NORTH PEAK ARCHITECTURE

Hancock Judicial Center Project Addendum #3 06-02-26

Project: Hancock Judicial Center

ADDENDUM #3 Mechanical/Electrical/Plumbing

SX-1

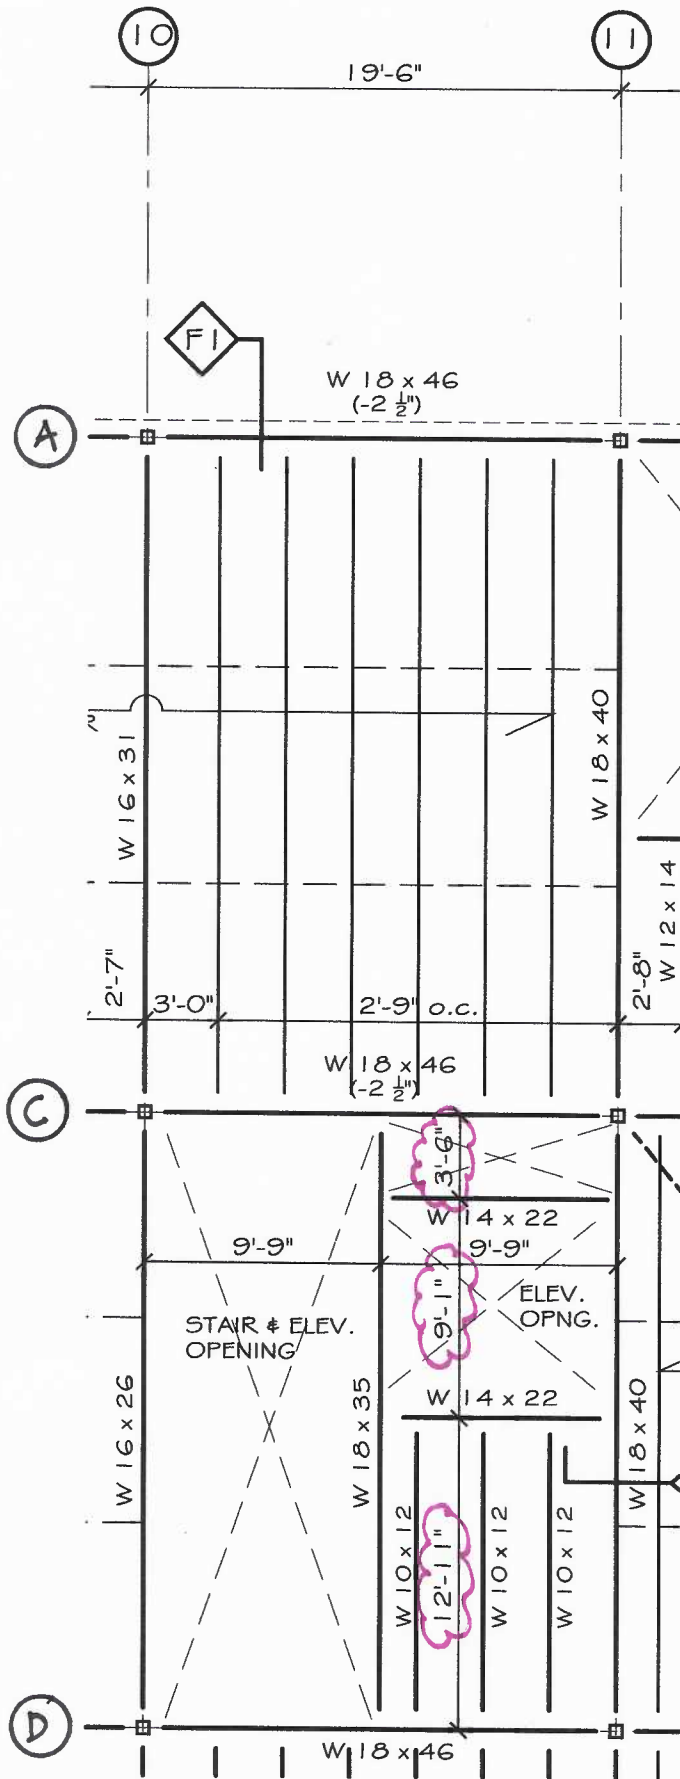
25. Attached page SX-1 "Bar Joist Indicator Line Revised" Sketch shall be part of this Addendum.

REFER TO ROOF FRAMING PLAN SHT. FC
 BAR JOIST INDICATOR LINE REVISED

SX-2

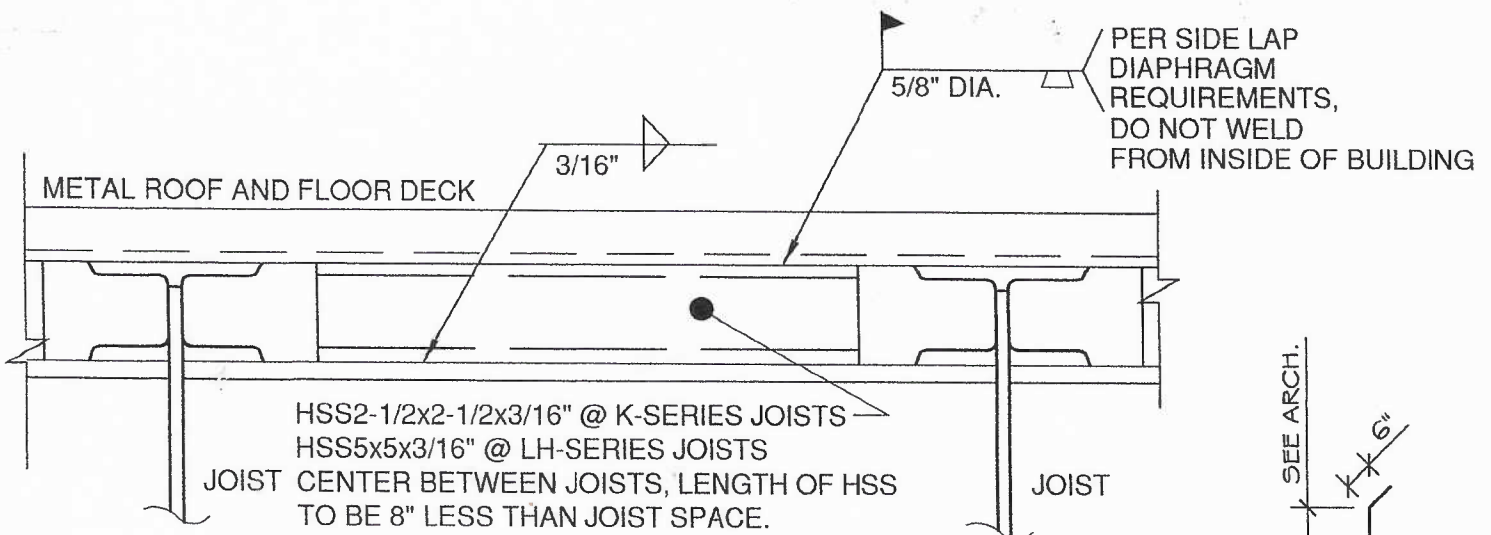
Attached page SX-2 "Revised Dimensions for Framing Plans F4 & F5" shall be part of this Addendum.

REFER TO 1ST FL. FRAMING PLAN SHT. F4 and
 2ND FL. FRAMING PLAN SHT. F5

REVISED DIMENSIONS AS INDICATED

TYP. SHEAR COLLECTOR DETAIL

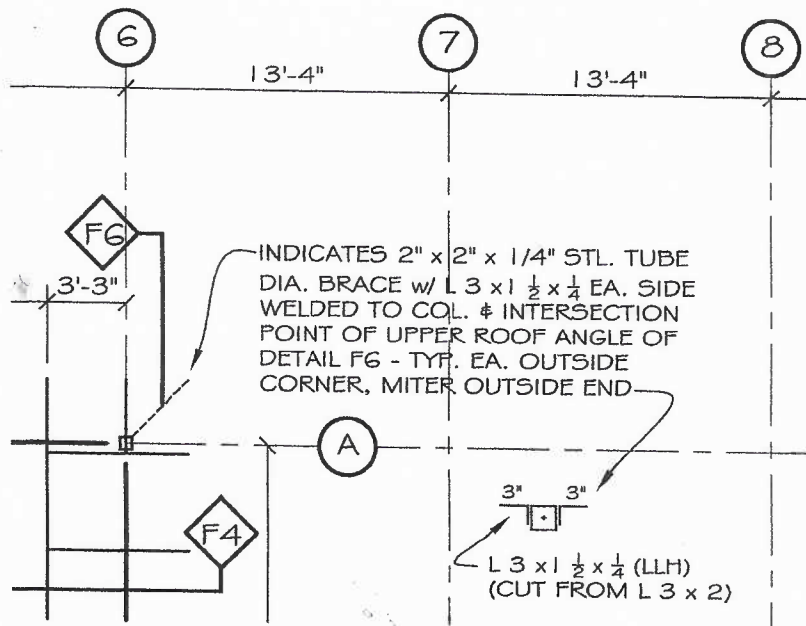
Attached page SX-3 "Revised Shear Collector Detail/Notes" & "Revised Roof Corner Brace Detail/Notes" shall be part of this Addendum.
26. Attached Mechanical / Electrical / Plumbing Items (4 Pages) are part of this Addendum.
27. Attached Sketches are part of this Addendum:
Site Plan – EV Foundation Location for Public Parking – Sht. 1 of 3
Site Plan – EV Foundation Location for Employee Parking – Sht. 2 of 3
Detail Sheet 10 – Sheet C-511 – EV Foundation with Bollards – Sht. 3 of 3

REFER TO DRAWING SHT. F11
 REVISED SHEAR COLLECTOR DETAIL/NOTES

REFER TO DRAWING SHT. F6
 REVISED ROOF CORNER BRACE DETAIL/NOTES

HSS2-1/2x2-1/2x3/16" @ K-SERIES JOISTS
 HSS5x5x3/16" @ LH-SERIES JOISTS
 JOIST CENTER BETWEEN JOISTS, LENGTH OF HSS
 TO BE 8" LESS THAN JOIST SPACE.

NOTE: USE 3/8" BENT PLATE AT GRIDS - C from 3 to 4, 9 to 10, 13 to 14
 - F from 2 to 3, 4 to 5, 10 to 11 - G from 12 to 13
 PROVIDE HSS AT ALL BRACED FRAME LOCATIONS EA. FLOOR IN
 ADDITION TO THESE 2ND FLOOR LOCATIONS: GRID A from 3 to 4 -
 GRID C from 9 to 10 and 13 to 14 - GRID H from 7 to 8 and 9 to 10 - GRID
 J from 7 to 8 and 9 to 10

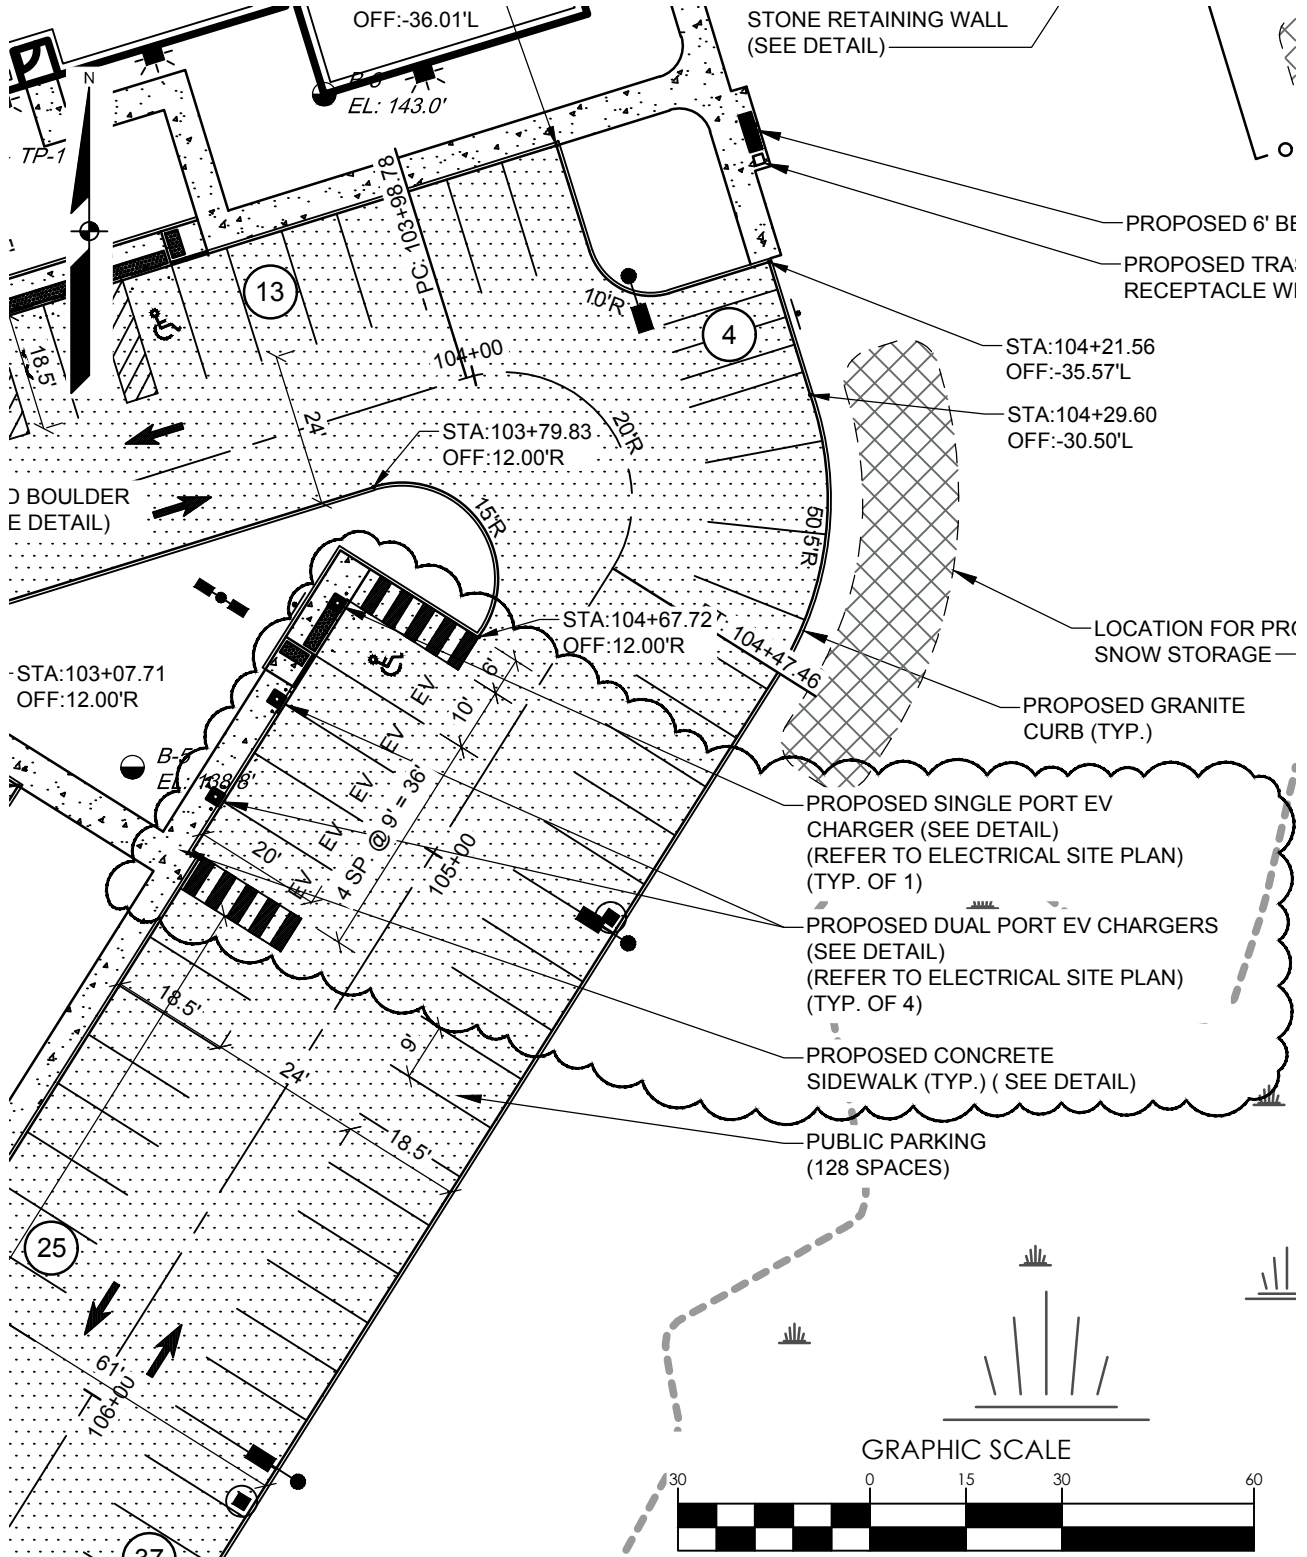
Drawing E2.1 & 2: Question –"Wire Feeder & Conduit Size Schedule" - Clarification.

Response; Change type "B" to read " 4 - #350kcmil Cu with 1 - #300 kcmil ground, (2 sets) in two 4" conduits. On Plan E2.1 & 2.2, replace type "I" feeder type to read "B" type.

DETAIL SHEET 10 - SHEET C-511
EV FOUNDATION WITH BOLLARDS

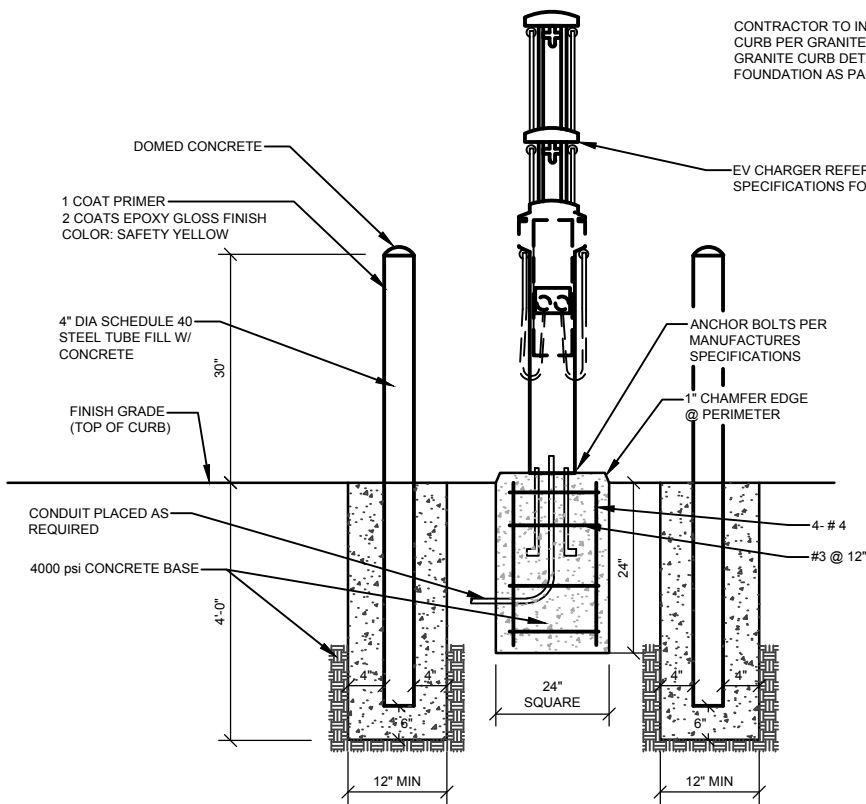
NOTE:
BOLLARDS AND EV FOUNDATION
TO BE INSTALLED DURING
CURB PLACEMENT.

CONTRACTOR TO INSTALL CONCRETE AROUND
CURB PER GRANITE CURB DETAIL, (REFER TO
GRANITE CURB DETAIL), BOLLARDS, AND EV
FOUNDATION AS PART OF CURB INSTALLATION.
